From: [REDACTED]
To: [M42 Junction 6; Bartkowiak, Bart](#)
Subject: Philip O'Reilly - M42 Jct6 - Deadline 9 Submission
Date: 15 November 2019 23:16:36
Attachments: [Mr Philip O'Reilly - M42 Jct6 - Response to Highways England Deadline 8 Documents 8.93, 8.94 & 8.95.pdf](#)

Response to Highways England Deadline 8 Documents 8.93, 8.94 & 8.95:

8.94 Actions Arising out of ISH on dDCO 4 on 23 October for Deadline 8

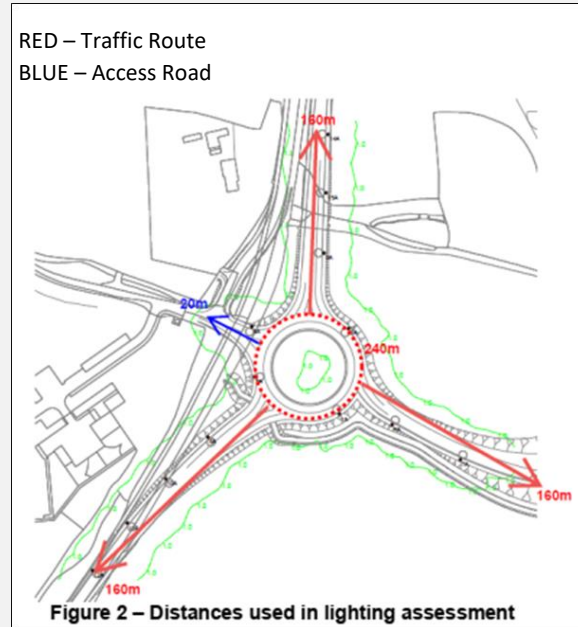
In my Deadline 3 submission 'Response to Highways England Deadline 2 Documents 8.20, 8.23, 8.25 & 8.26' (published on 17th July 2019) I questioned the validity of the data in HE document '8.23 Lighting Technical Note', and in particular the distances HE had used for 'Barber's Coppice Roundabout'.

"In relation to Barber's Coppice Roundabout, the distance given covers the whole of the 'conflict area' including all approach roads and the roundabout circumference consequently 0.74km is the correct distance for Barber's Coppice Roundabout. The Benefit Cost Ratio value for the roundabout given in the Lighting Technical Note is therefore correct".

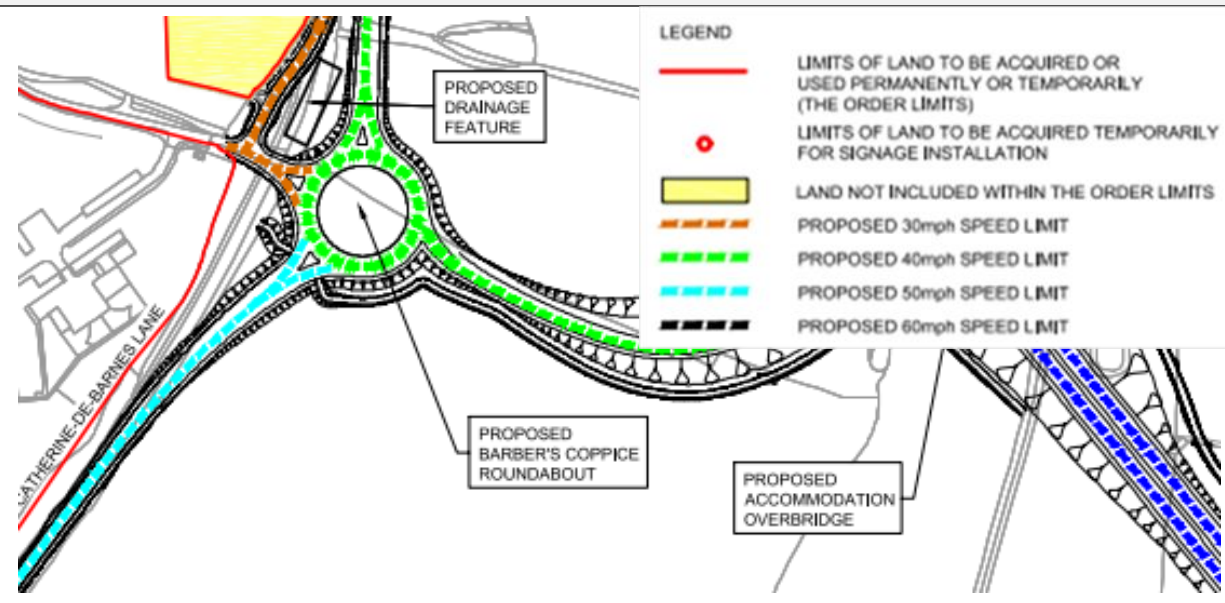
As can be seen from Figure 2 the total length of Barber's Coppice roundabout and its approaches is $240+160+160+160+20=740m$ ".

In their response they state that ". . . the assessments contained in lighting technical note were conducted during preliminary design at a point in time where both the design speed assumptions and overall scheme layout were still being developed. This means that the current design differs from the preliminary design in respect of roundabout size, roundabout alignment, and the design speed for Catherine-de-Barnes Lane".

In terms of roundabout size, the roundabout is now proposed to be 220m rather than 240m.

The roundabout alignment is not significantly different.

The design speeds have not changed.

HE repeatedly stated that the total length of Barber's Coppice roundabout and its approaches was 740m. They now say it has only changed as a result of design changes.

If it was solely down to design changes, the revised length would be $740\text{m} - 20\text{m} = 720\text{m}$. It isn't.

As stated in the Applicant's comments on any additional information or submissions received by Deadline 3 [REP4-008/Volume 8.56], the lengths defined for Barber's Coppice roundabout include "all approach roads and the roundabout circumference". The approach lengths are based on the stopping sight distances, which in turn are based on the design speed of each road. The distances are outlined in the figure shown below:

In their Deadline 6 document, HE provide the following drawing to illustrate the distances used in their lighting calculation for 'Barber's Coppice Roundabout':

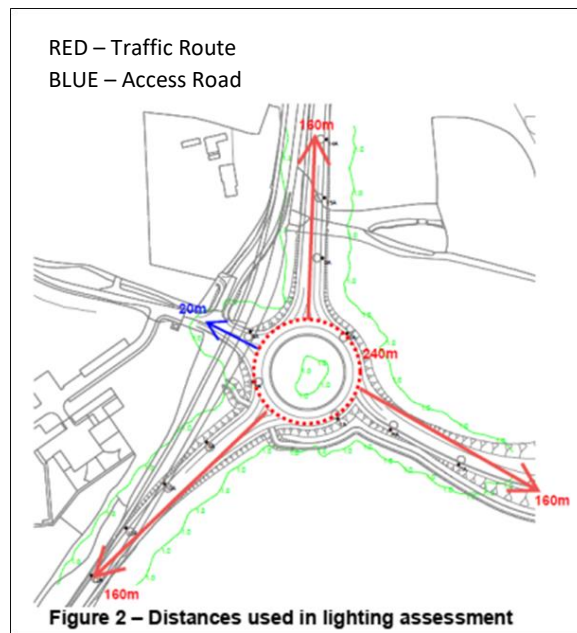
Unfortunately, the distances shown on the drawing are incorrect.

'Barber's Coppice Roundabout' has a circumference of 220m, taken from AutoCAD drawing provided by HE - 'HE551485-ACM-HML-M42_ML_01_ZZ-SK-CH-0002'. It is not 240m as shown.

The Merge Slip from 'Barber's Coppice Roundabout' to proposed Mainline link is not an approach road to 'Barber's Coppice Roundabout'. 160m has therefore been included in error.

The northern approach road to 'Barber's Coppice Roundabout' has a speed limit of 40mph. The desirable minimum stopping sight distance is therefore 120m. It is not 160m as shown.

The southern approach road to 'Barber's Coppice Roundabout' has a speed limit of 50mph. The desirable minimum stopping sight distance is therefore 160m, as shown on the HE drawing.

∴ The length of 'Barber's Coppice Roundabout' is 220m + 120m + 160m + 20m = **520m (NOT 740m)**
